PDR 71-9135

Gamma Industries

REFERENCE: Docket No. 71-9135

Enclosed are items to be inserted into the application for NRC Certificate of Compliance application on "Century" model devices manufactured by Gamma Industries.

PUNCTURE-IMPACT ORIENTATION TESTS

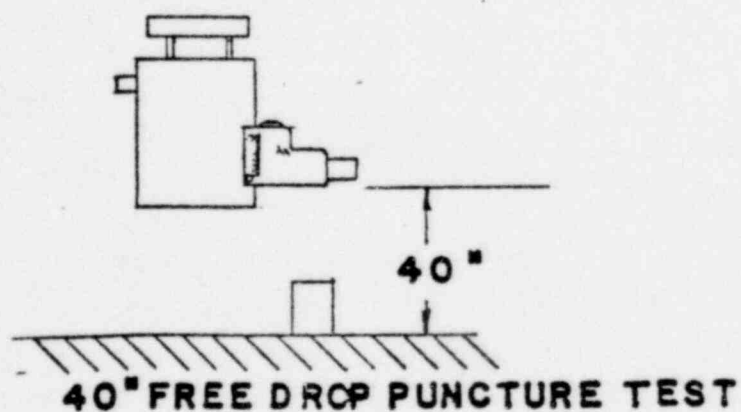
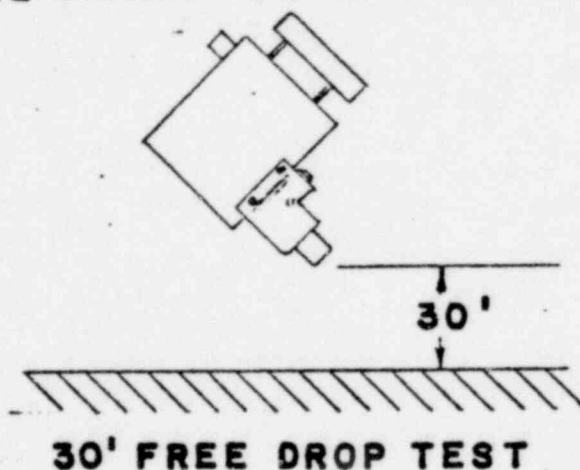
3. Revision for pages 7.7A and 7.7B
This revision addresses the rationale for specific impact points for the drop and puncture test. Page 7.7B is a graphic showing the orientation of the device in both the drop and the puncture test.

Second, in attempting to determine which impact point would be likely to inflict the most damage, it was believed appropriate to select a drop from 40 inches

with a direction and attitude which would cause maximum stress on the lockbox "flanges" and the bolts. The drop was made in such a manner that the initial impact point upon the steel bar was near the outer end of the lockbox. This would provide the maximum bending moment upon the lockbox and also provide shear stresses upon the bolts.

No adverse results to holding integrity were observed after these tests were completed.
